IEEE P802.3az/D1.1 Clause 24 Receive State Diagram Corner Case Analysis

Peiqing Wang and Mike Grimwood, Broadcom

IEEE P802.3az Task Force
New Orleans, January 2009

Clause 24 Receive State Diagram

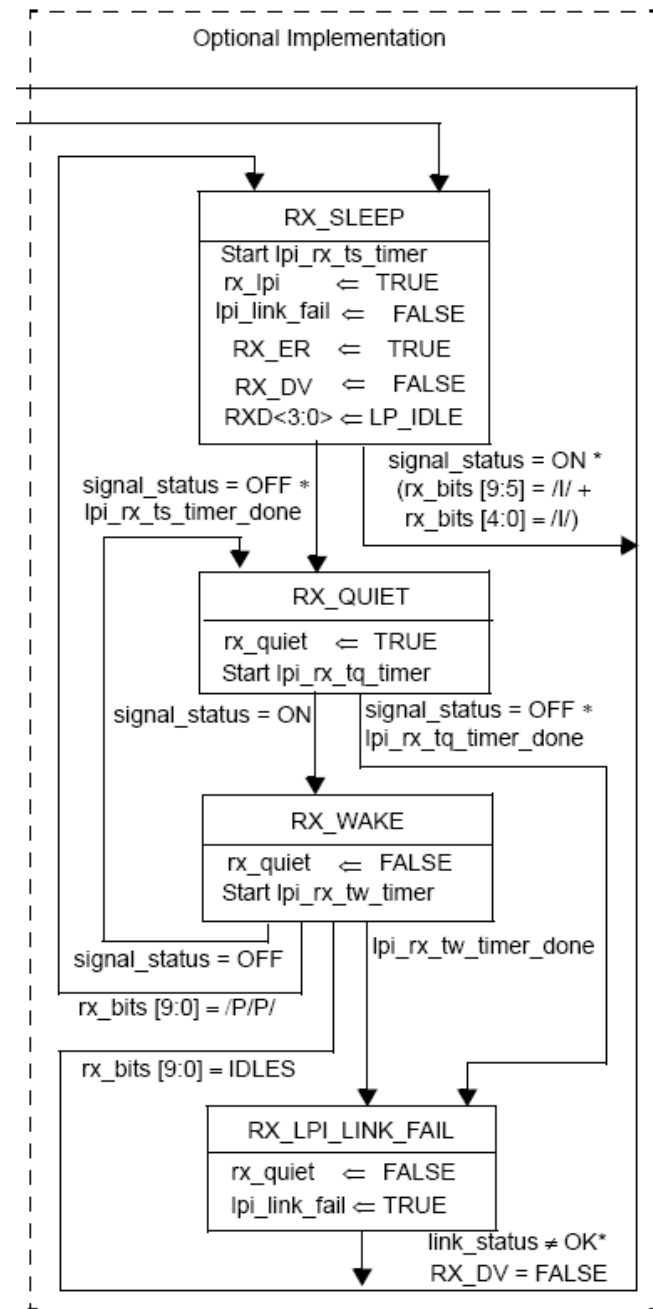
- Corner-case condition can occur if signal_status toggles between ON and OFF with the following sequence and associated states:
 1. State is RX_QUIET and signal_status toggles to ON.
 2. State transitions to RX_WAKE and lpi_rx_tw_timer is reset.
 3. signal_status toggles to OFF prior to lpi_rx_tw_timer expiring causing a transition back to RX_QUIET, causing lpi_rx_tq_timer to be reset.
 4. Prior to lpi_rx_tq_timer expiring, signal_status toggles to ON (2 through 4 can then repeat indefinitely).

Proposed Change to Clause 24 Receive State Diagram

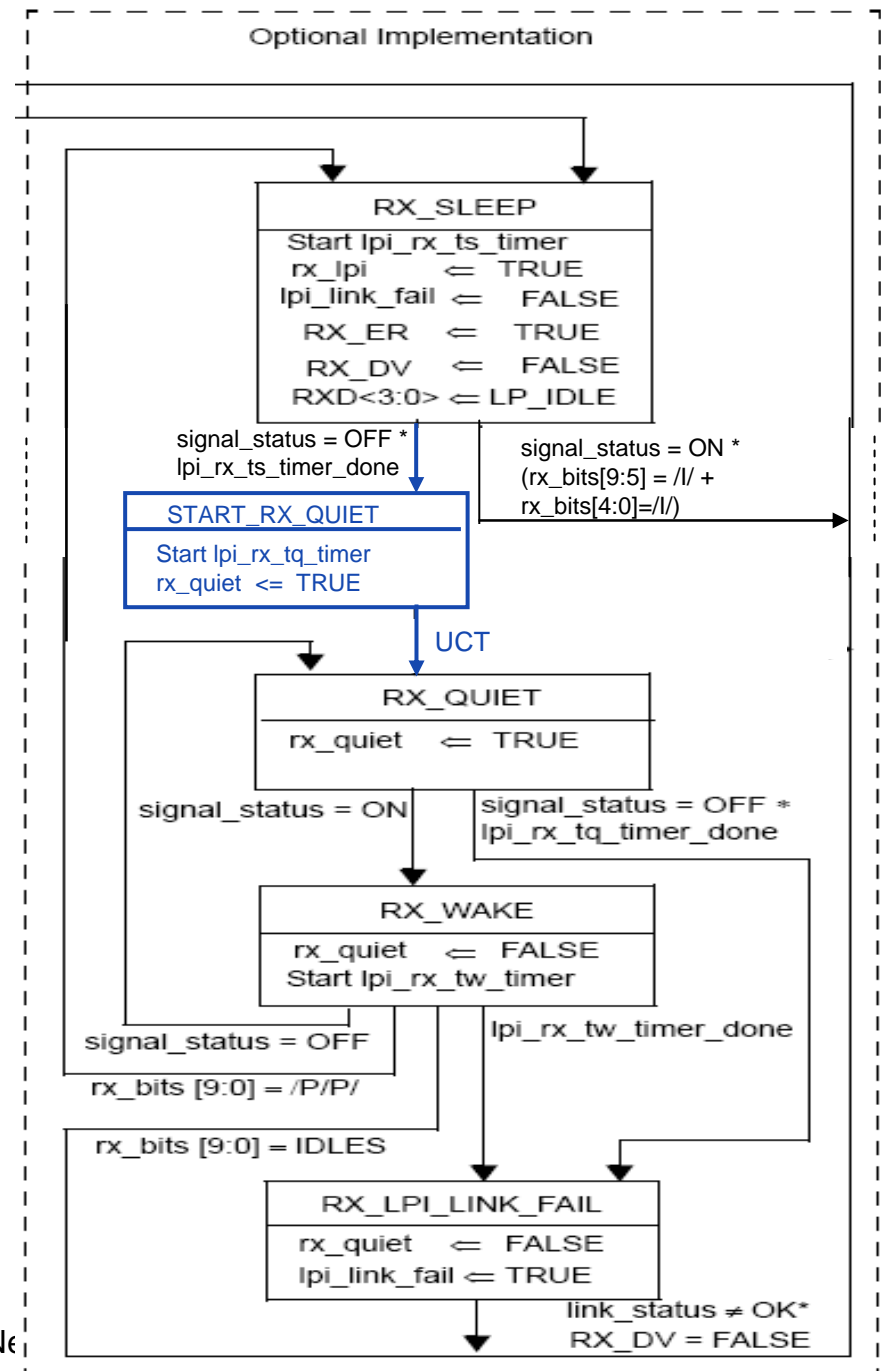
- Add state START_RX_QUIET to reset lpi_rx_tq_timer once at the beginning of each quiet period.
- This is equivalent to the existing state diagram except that lpi_rx_tq_timer is not reset upon re-entry to the RX_QUIET state.
